PLANNING & ZONING CASE NO. SP2025-033

PROJECT NUMBER: SP2025-033
PROJECT NAME: Site Plan for 102 West Bourn Street
SITE ADDRESS/LOCATIONS: 102 West Bourn Street, Rockwall, TX, 75087

CASE CAPTION: Discuss and consider a request by Dub Doupbrate of Doupbrate & Associates, Inc. on behalf of Kim Timpa for the approval of a Site Plan for an Office Building on a 1.1308-acre parcel of land identified as Lot 1, Block B, Jack Canup Addition, City of Rockwall, Rockwall County, Texas, zoned Planned Development District 62 (PD-62) for General Retail (GR) District land uses, addressed as 906 S. Goliad Street [SH-205], and take any action necessary.

TO: Planning and Zoning Commission
DATE: September 30, 2025
APPLICANT: Dub Douphrate; *Douphrate and Associates*
CASE NUMBER: SP2025-033; *Site Plan for Timpa Law Office*

FRONT ELEVATION

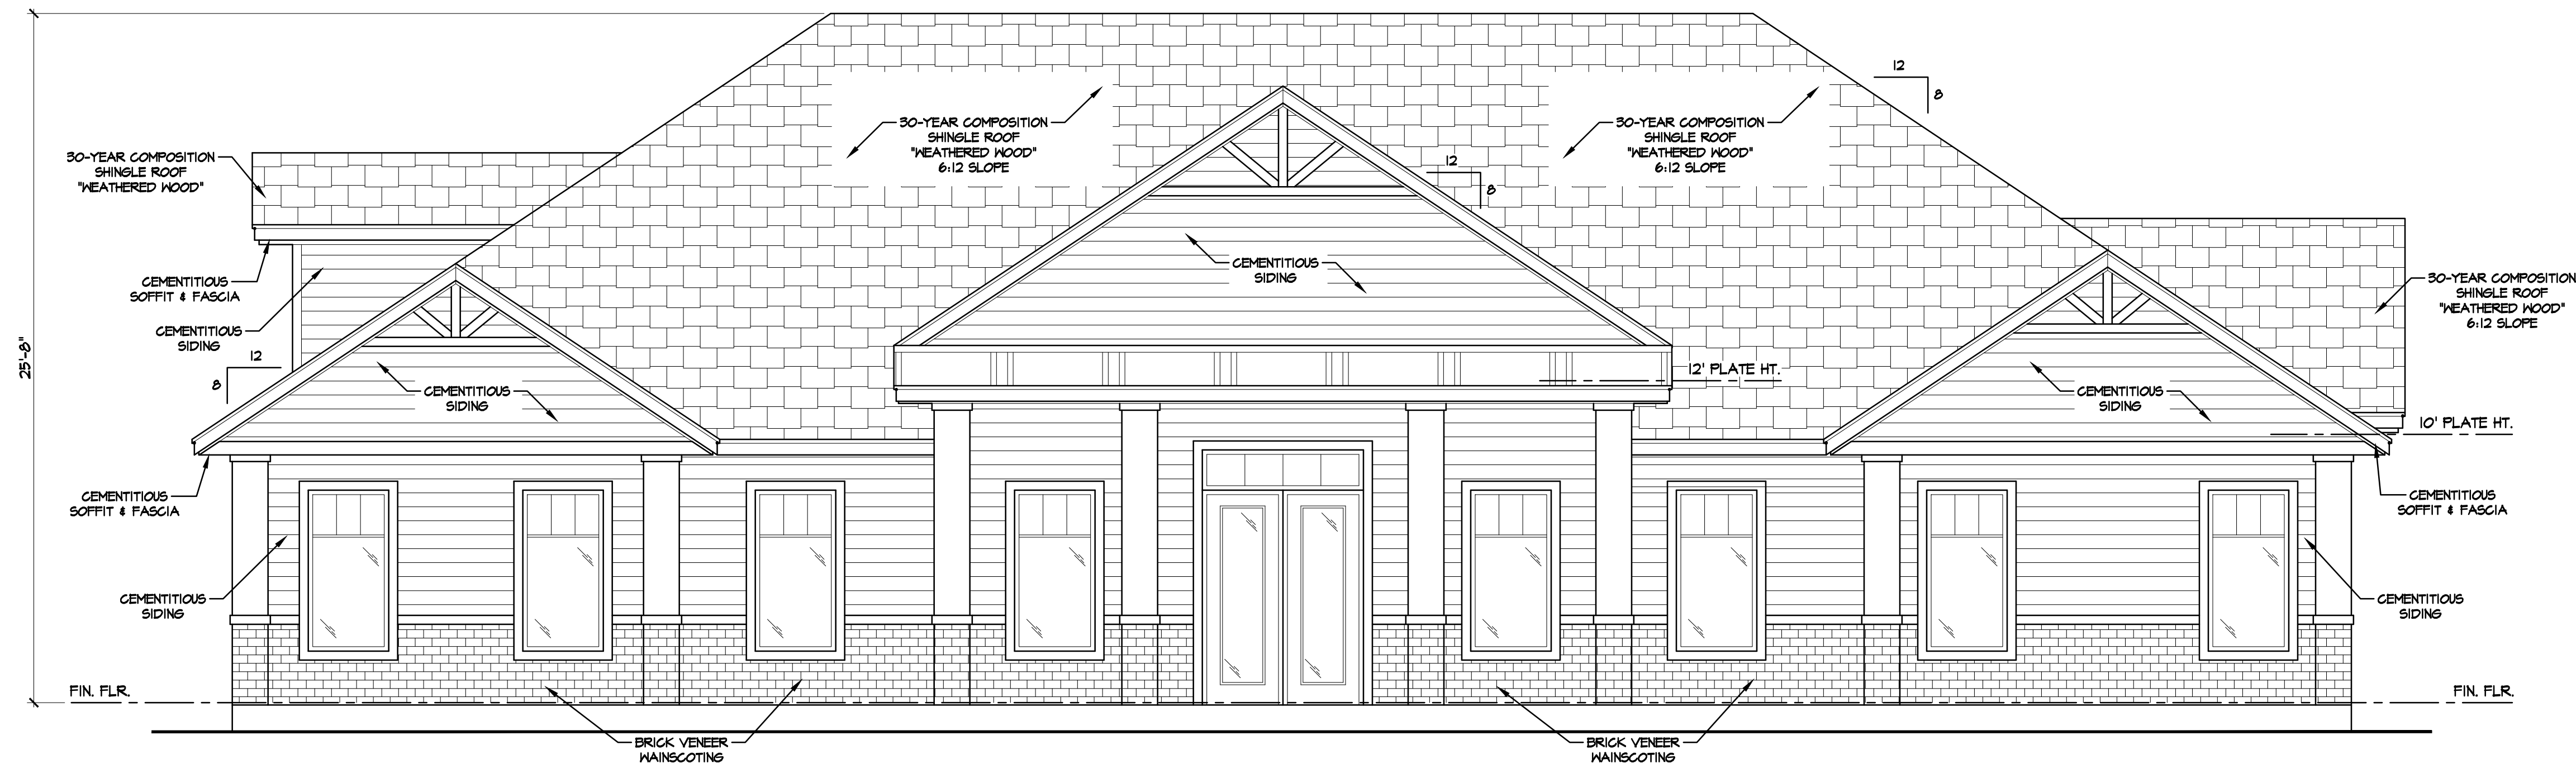
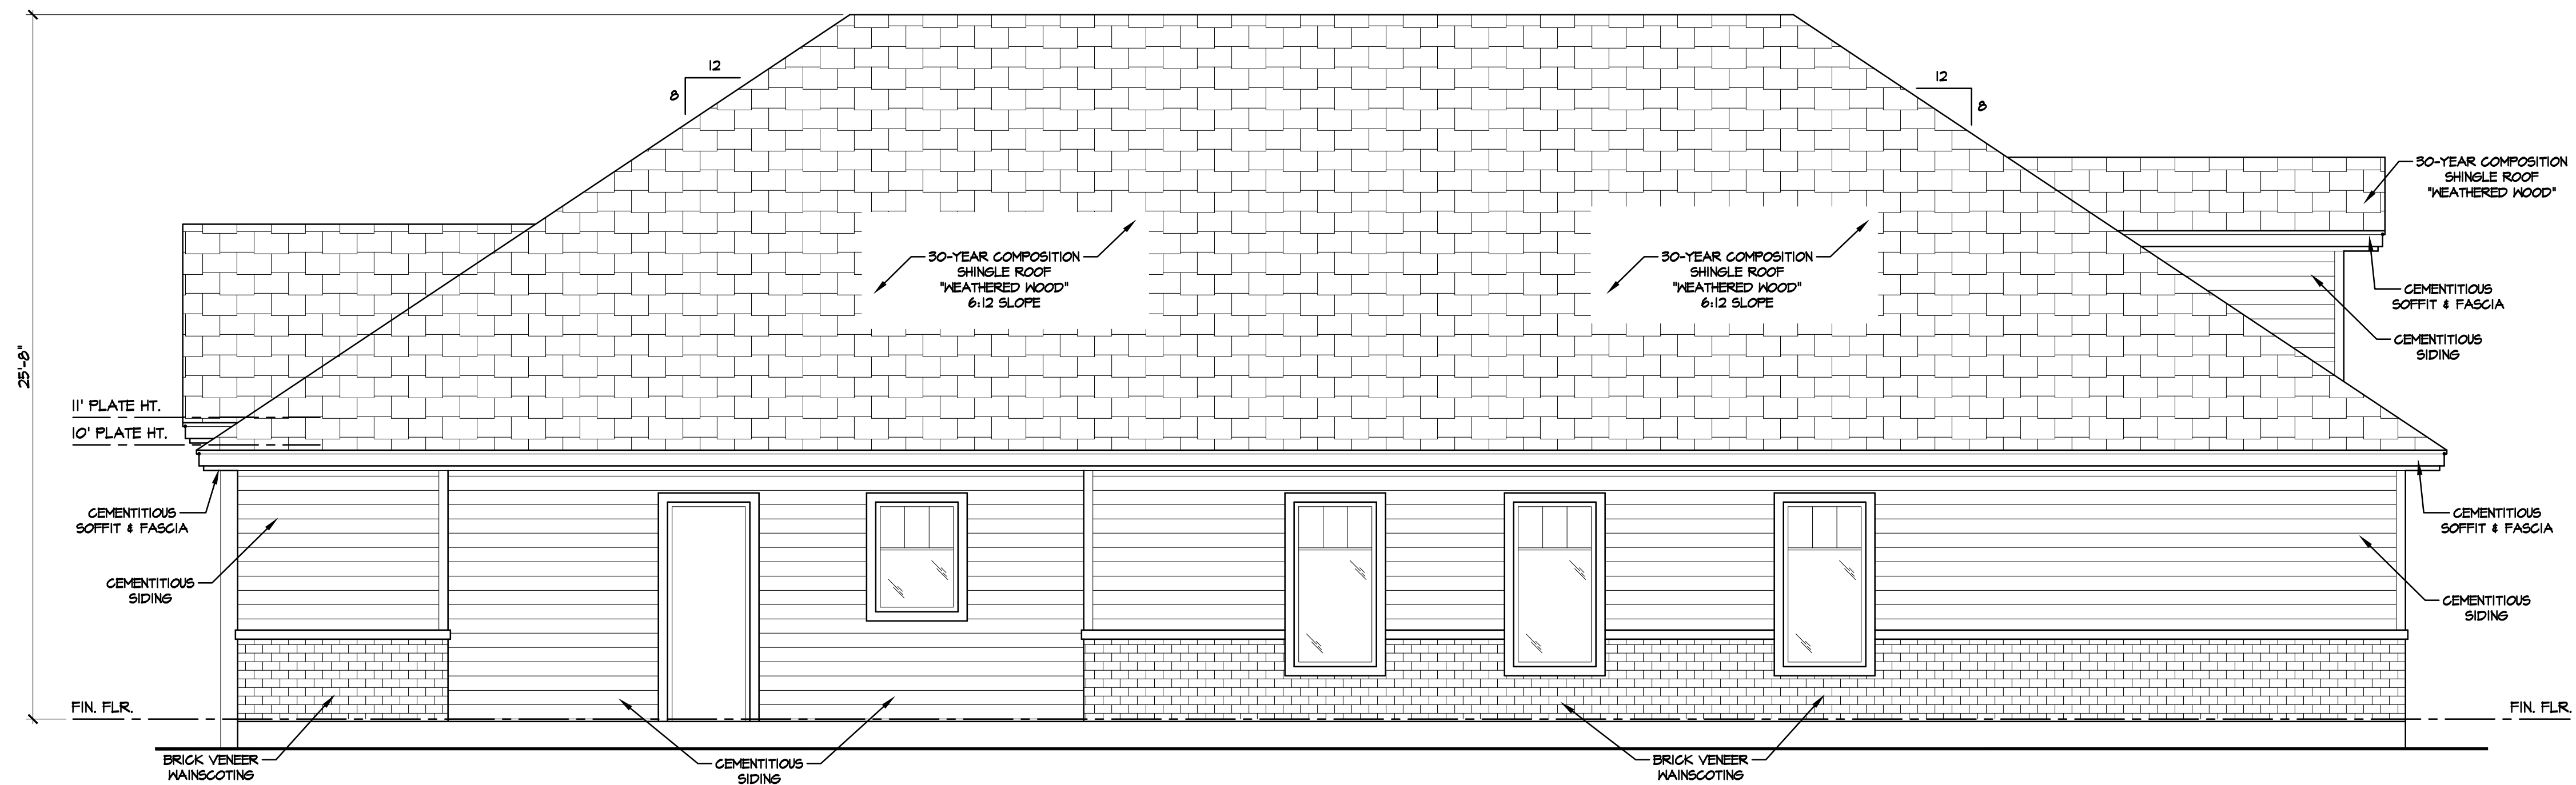
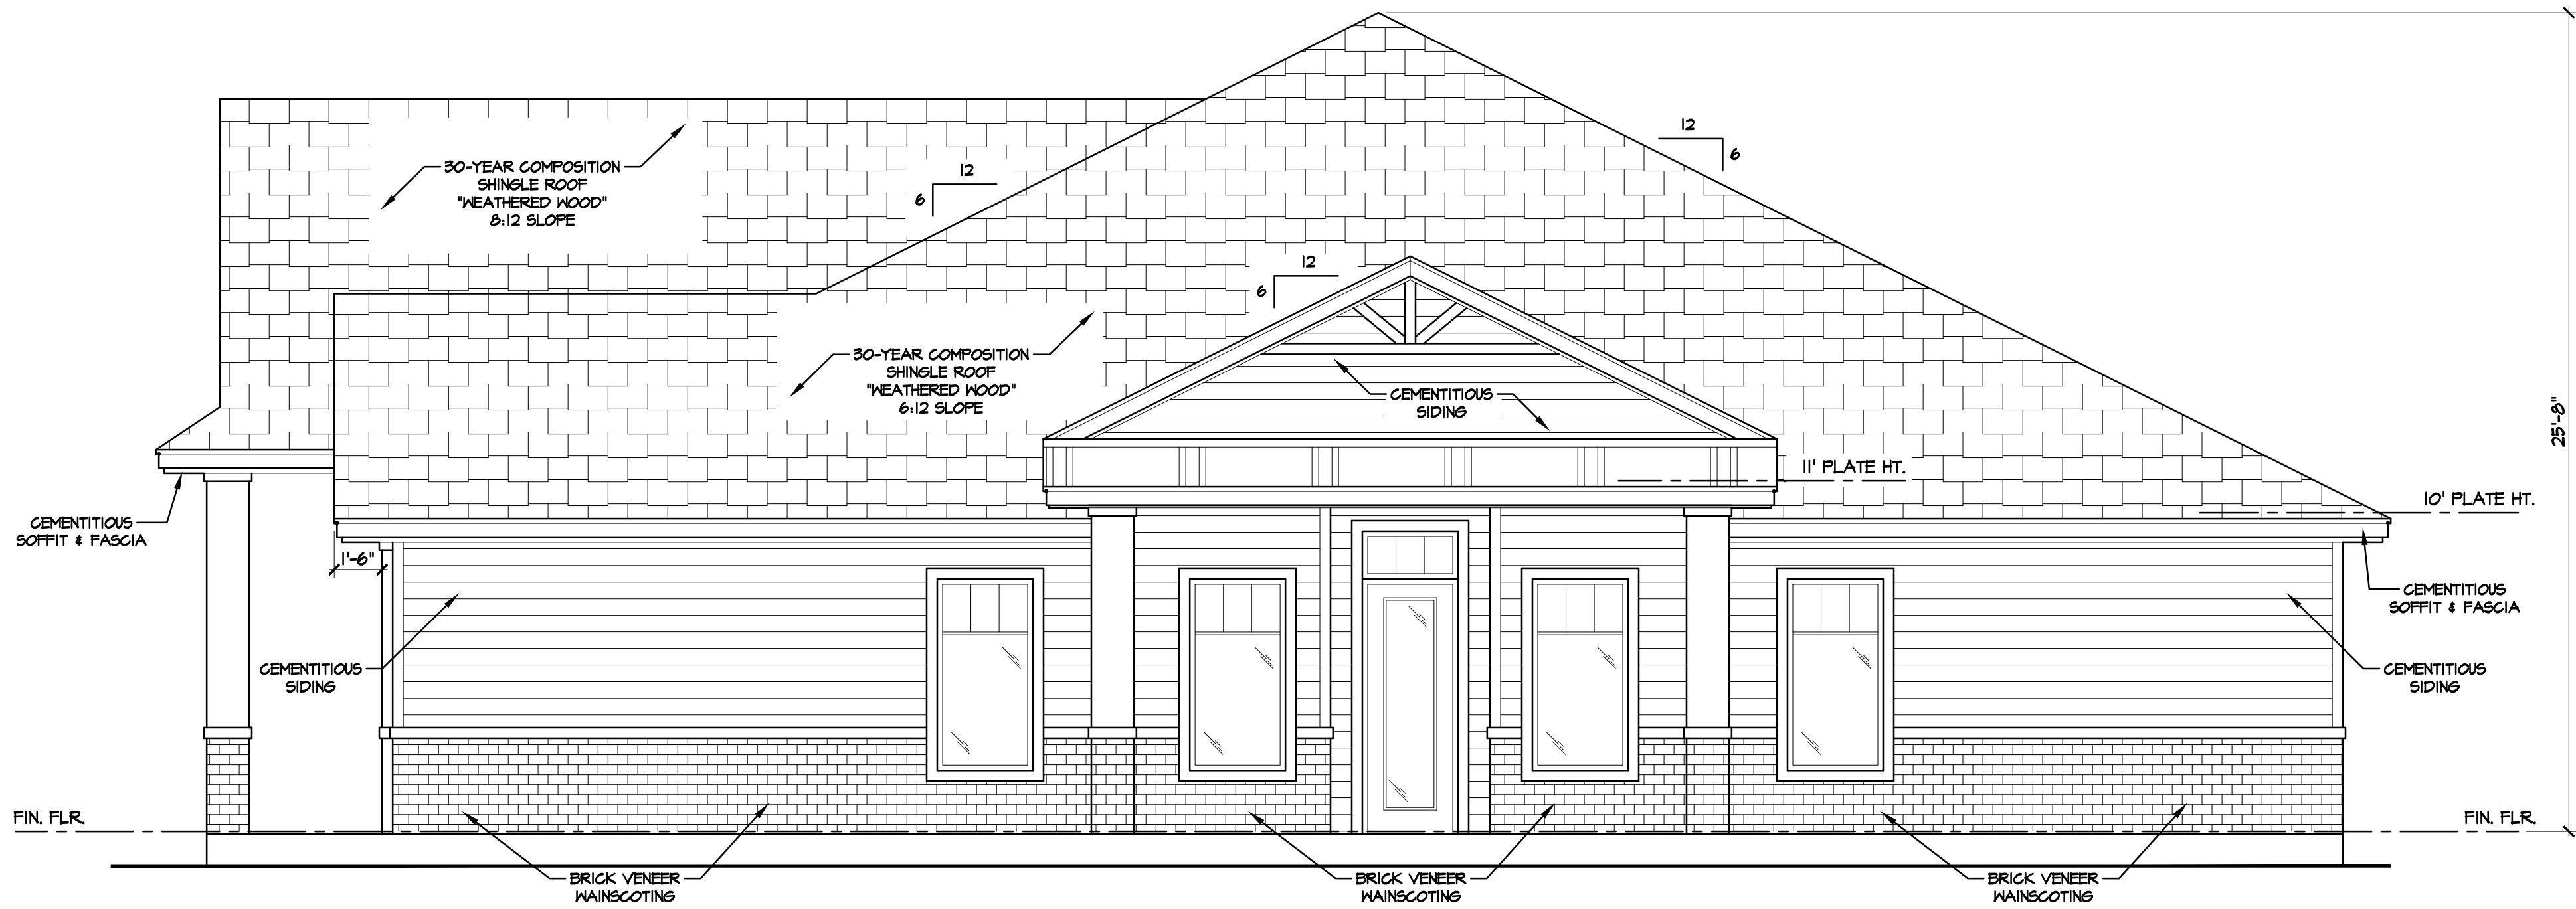
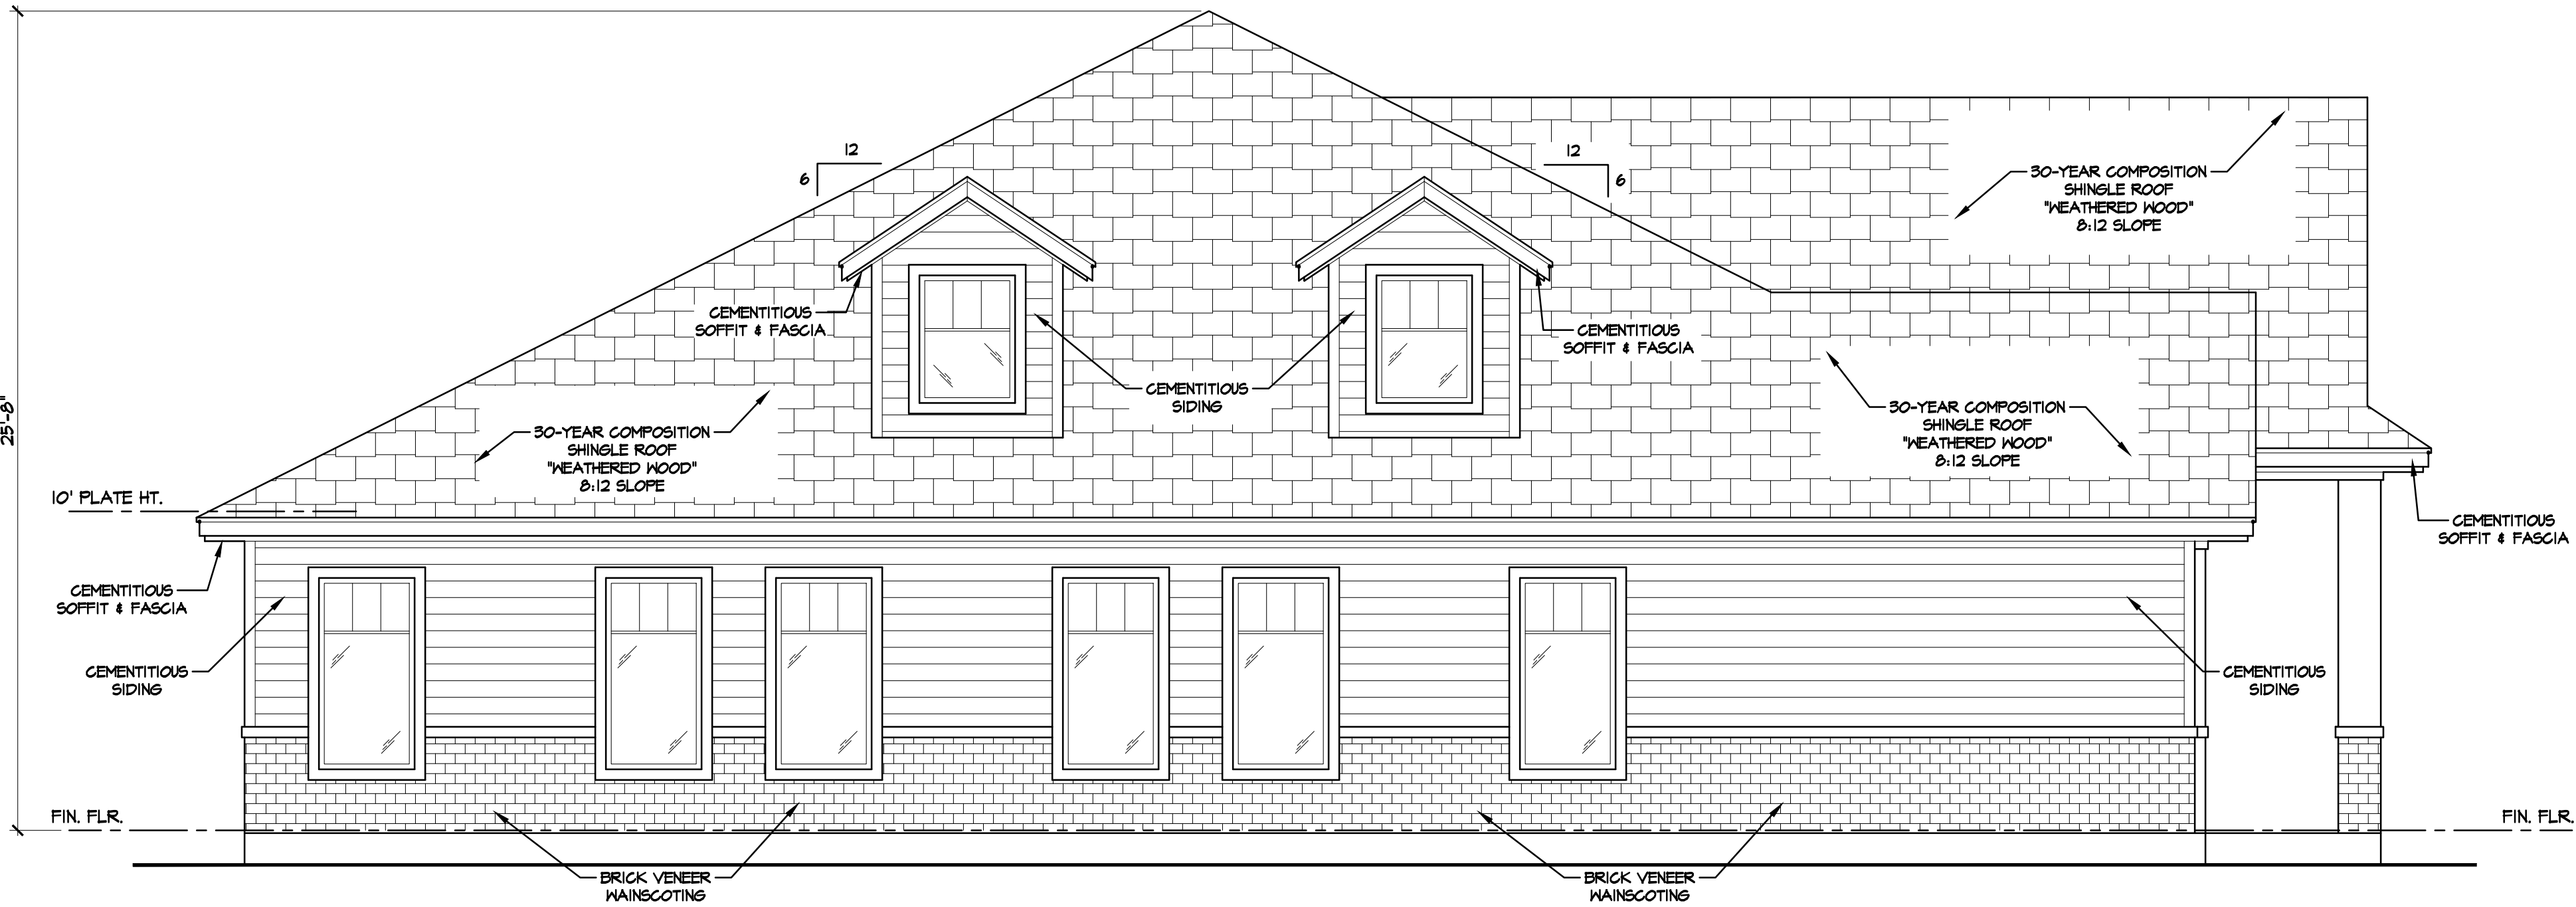
(5) The proposed buildings' facades do not meet the Commercial Building Articulation Standards for wall projections. (Subsection 04.01.C, of Article 05, of the UDC) This will require an exception from the Planning and Zoning Commission.

- (1) *Building Articulation*. According to Subsection 04.01 (C)(4), *General Commercial District Standards*, of Article 05, *District Development Standards*, of the Unified Development Code (UDC), a secondary building façade wall length “shall not exceed three (3) times the wall height.” In this case, the rear and left building elevation exceeds this requirement. This will require an exception from the Planning and Zoning Commission pending a recommendation from the Architectural Review Board (ARB).

The Architectural Review Board (ARB) reviewed the building elevations provided by the applicant on August 26, 2025, and requested that the applicant double front the building so that it appears to have entrances on to S. Goliad Street and Bourne Street. The applicant has made the requested changes and prior to action being taken on this case the Architectural Review Board will review the building elevations and provide a recommendation to the Planning and Zoning Commission for the September 30, 2025 meeting.
